II.B.1 HIGH POINT VENT  
NO. 2 UNIT  
SALEM NUCLEAR GENERATING STATION  
DOCKET NO. 50-311

ADDITIONAL INFORMATION  
RCS VENTS  
NO. 2 UNIT  
SALEM NUCLEAR GENERATING STATION

# HYDROGEN ACCUMULATION AFTER DBA

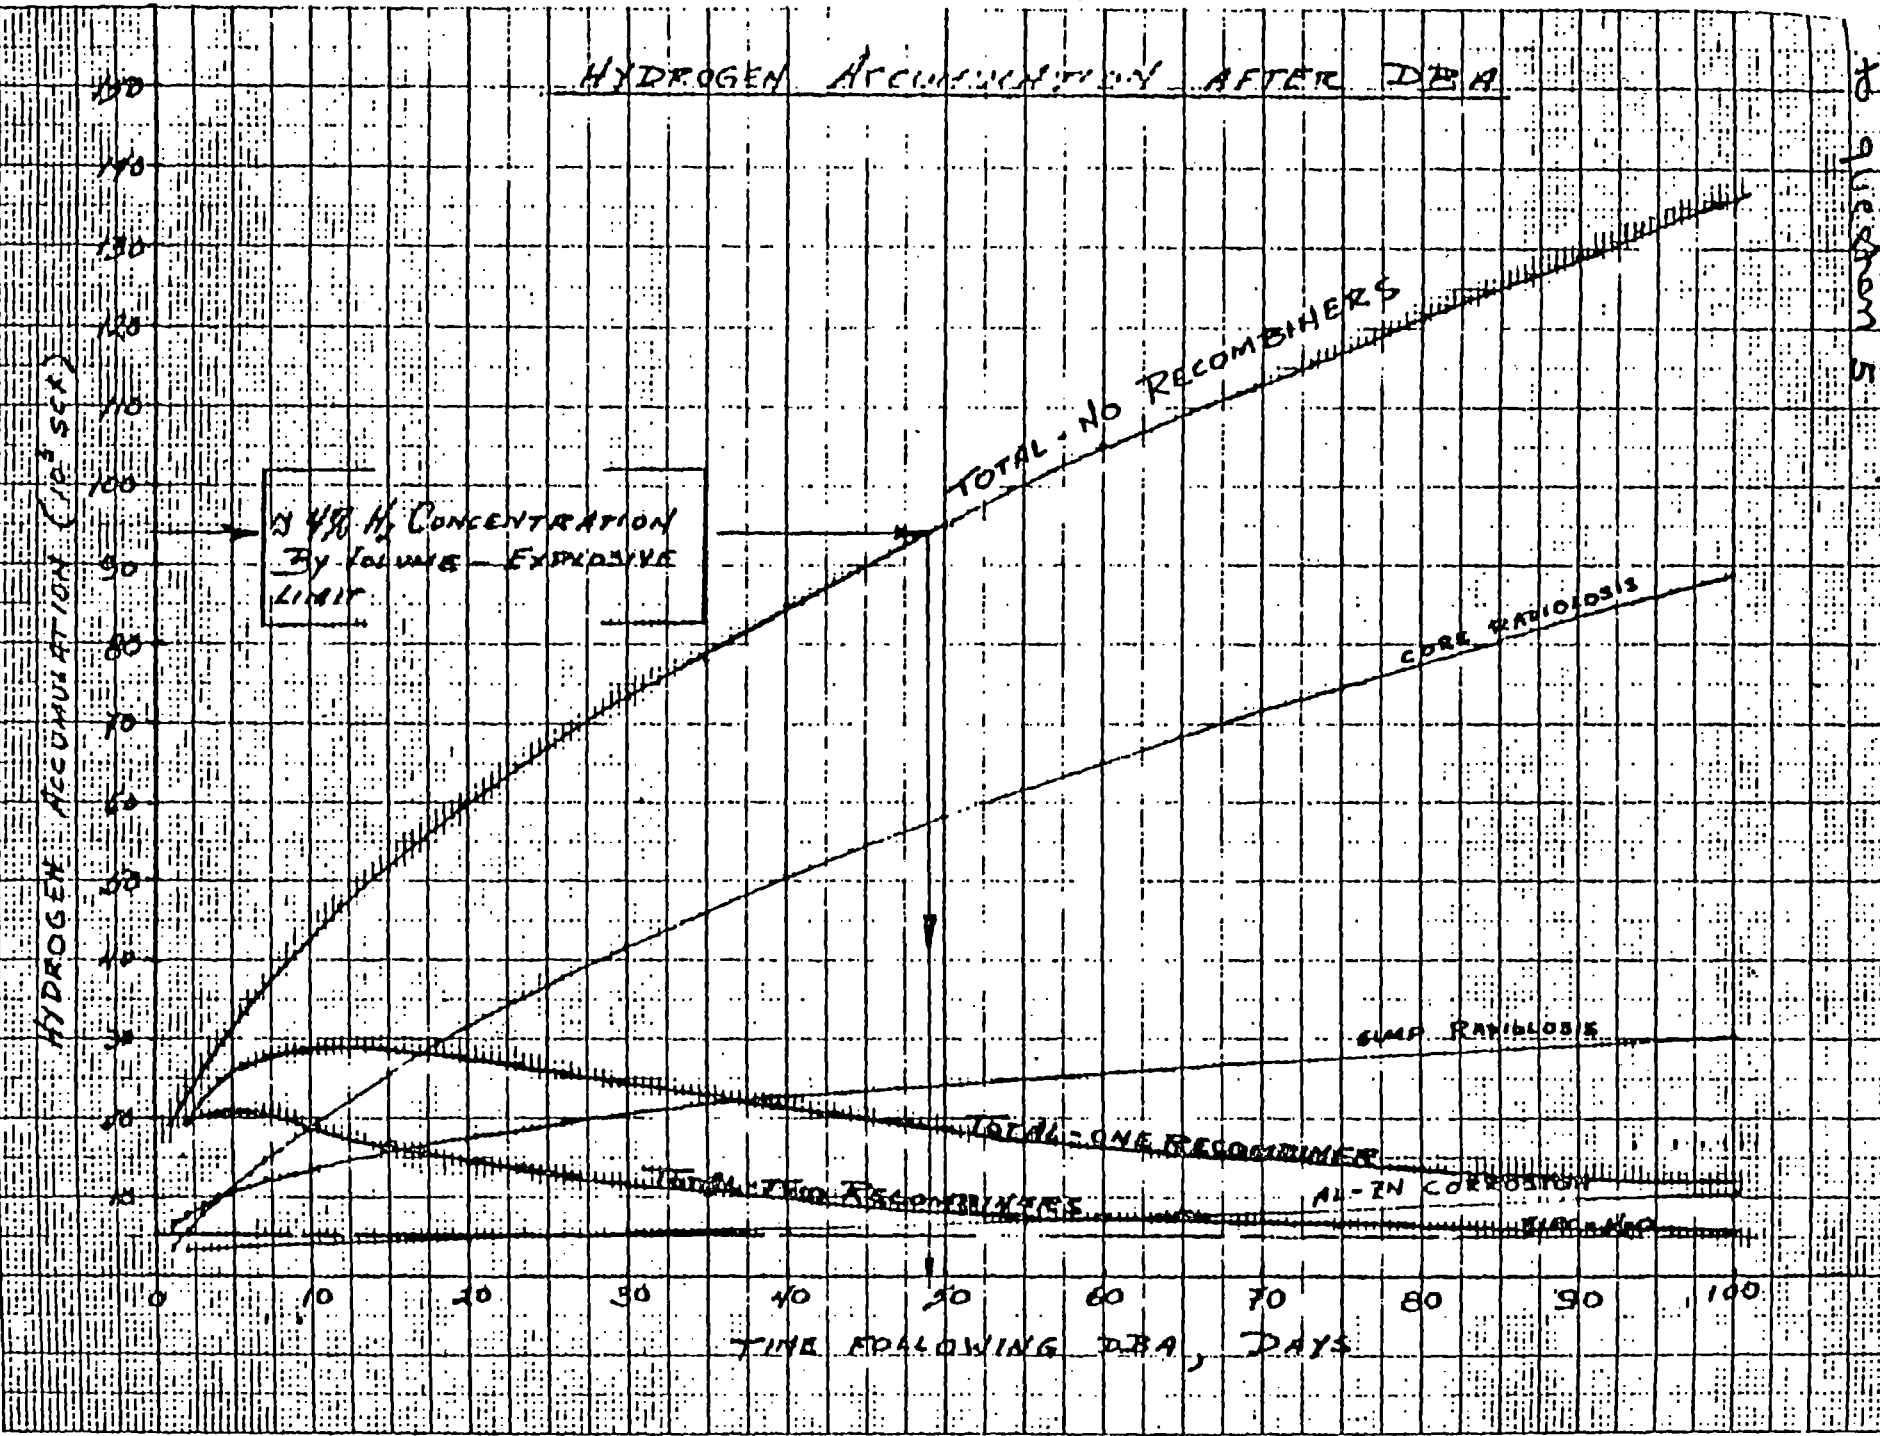
Provide procedural guidelines and analytical bases (preferably, generically developed by Owners Group) for vent operation and termination as related to plant performance. The procedures should be based on the following criteria: (1) the plant must meet the requirements of 10 CFR 50.46 and 10 CFR 50.44 for DBA's; and (2) the plants ability to maintain core cooling and containment integrity for events beyond DBAs must be increased. Procedures should also address methods to (1) assure natural circulation through the U-tube portions of the steam generator with the potential accumulation of gases in this region, and (2) assure that combustible limits are not exceeded.

Total hydrogen accumulated from all sources inside the containment was restudied (apart from FSAR Section 14.3.6 analysis) in the light of the TMI incident. The attached graph shows the hydrogen accumulations from various sources, with and without the operation of one or both of the hydrogen recombiners.

As is evident from the graph, the hydrogen concentration limit of 4 v/o (i.e., 4 percentage hydrogen concentration by

volume) as required by Regulatory Guide 1.7 is satisfied with adequate margin by operation of only one of the two hydrogen recombiners.
